# Product Change Notification

## 108260 - 00

**Change Notification #:** 108260 - 00  
**Change Title:** Intel Carrier Grade Server TIGW1U, PCN 108260-00, Product Design, Changed sheet metal to enhance rack mount options, GCM port, captive screw, and insulator, drive bay, and fan bracket.  
**Date of Publication:** February 26, 2008

Figure 1. Sheet Metal Changes to add Rail Kit Support

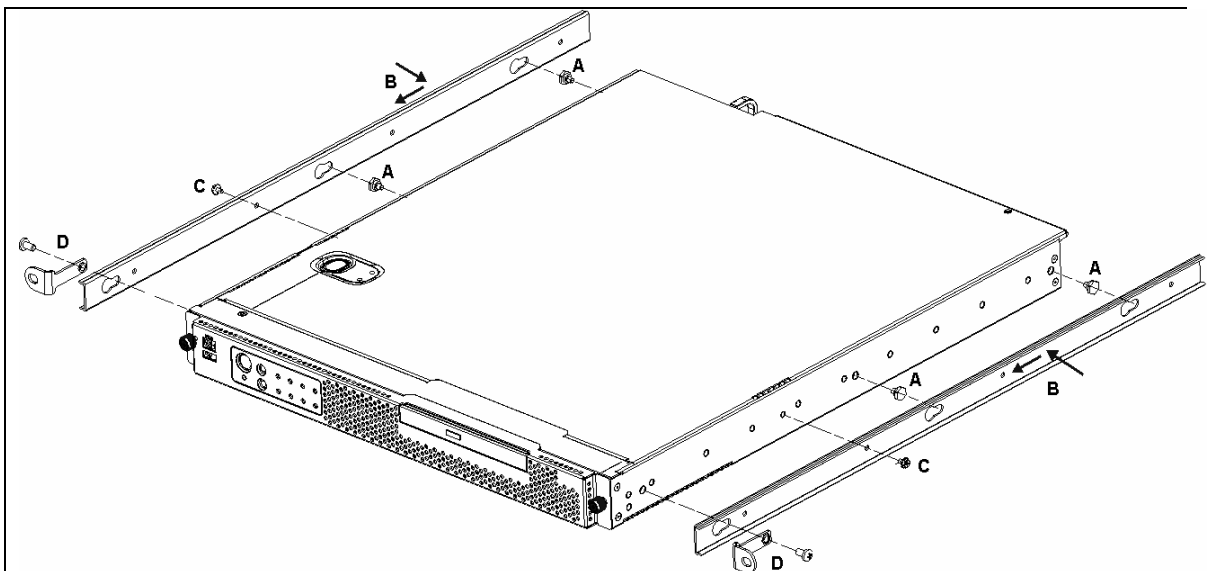
1. Changed base chassis to enable use of AXXBASICRAIL, AXXBASRAIL13, or AXXHERAIL (in non-NEBS environment). Change added:
  - a. Two new positions (A in figure 1 below) per side to add 4 Hex Shoulder Screws.
  - b. Additional position (C and D in figure 1 below) for attaching rail and mounting ear.

Figure 2. GCM NIC port sheet metal change.

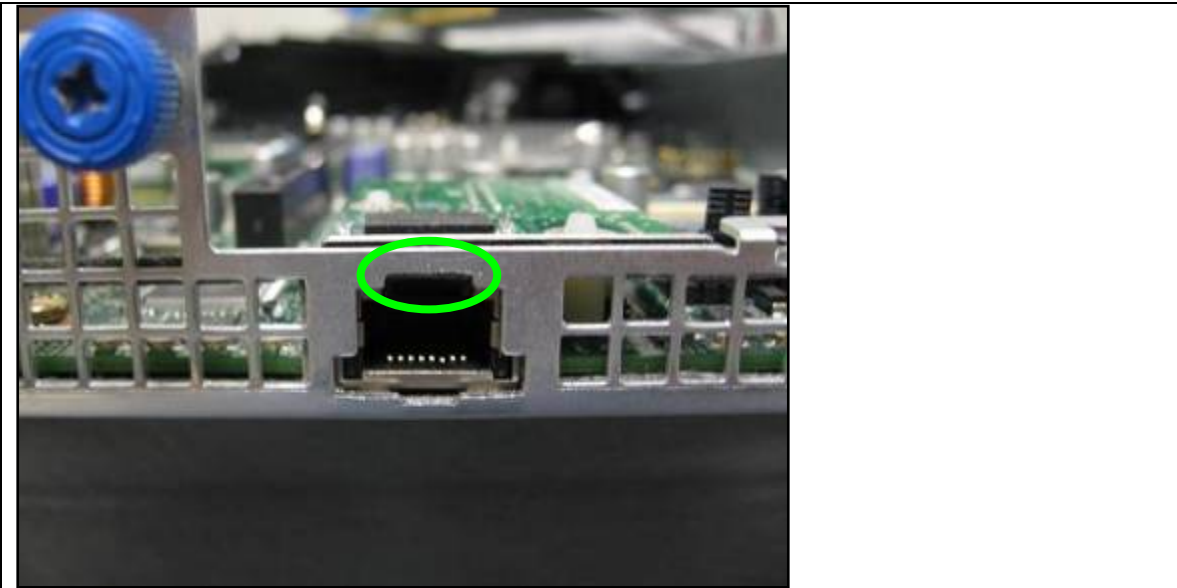
2. Changed GCM NIC port to add notch for better clearance when module is installed.

Figure 4. Added clip to drive bay

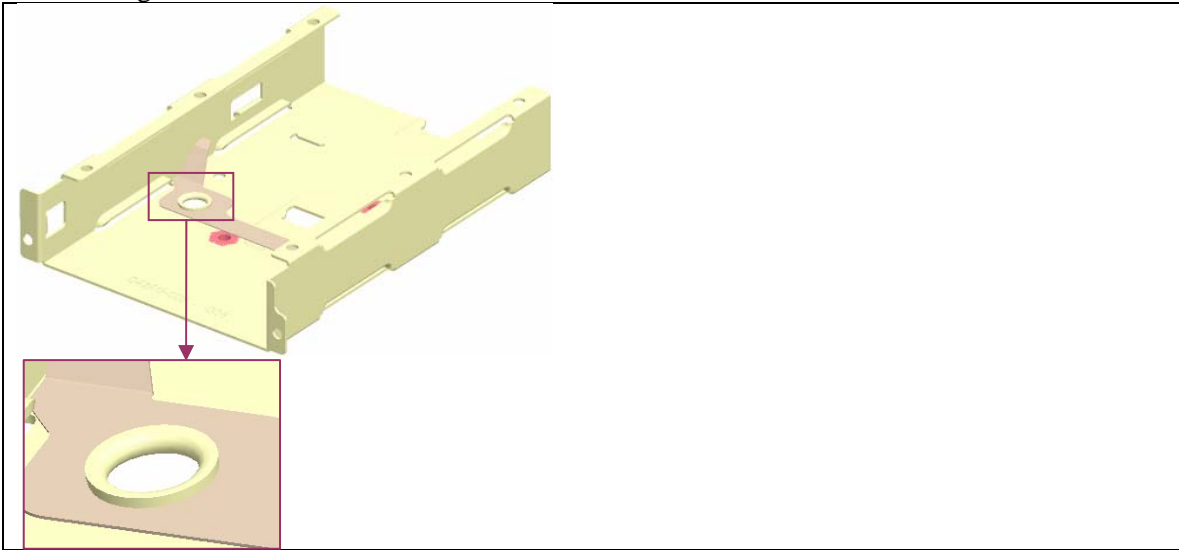
5. Added clips to the drive bay to reduce transmission of rotational vibration, as shown in Figure 4.

Figure 5. Changed Fan Bracket Sheet Metal.

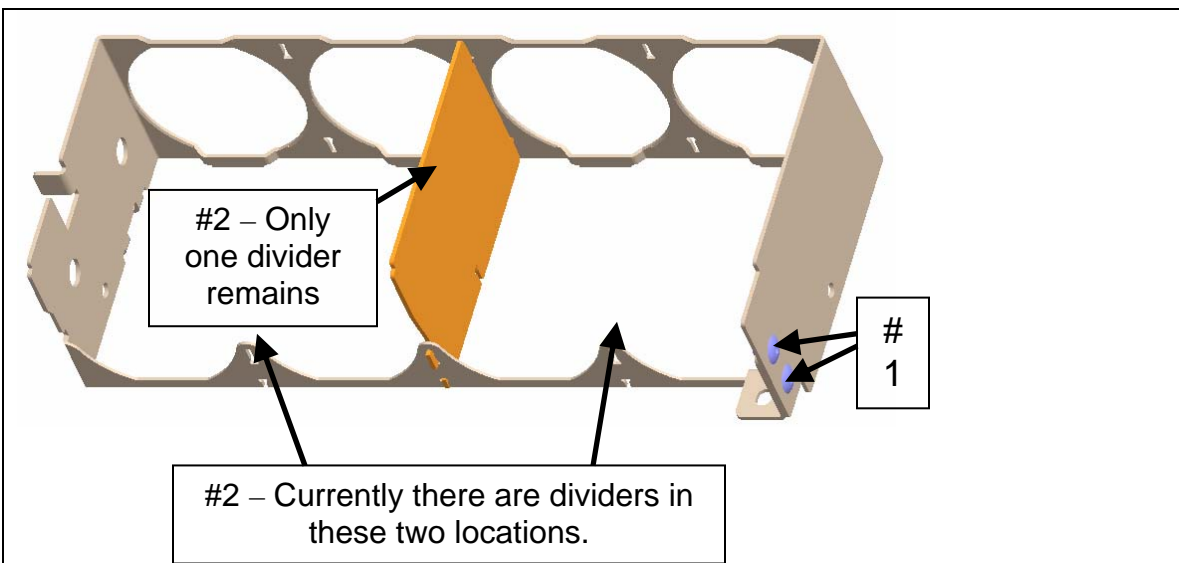
6. Changed CPU Fan Bracket sheet metal to improve RV (Rotational Vibration) performance.
  - a. #1. Re-located rivet holes on outside surface to eliminate the gap/twist problem.
  - b. Deleted two bay dividers (#2), leaving one divider for better RV performance.
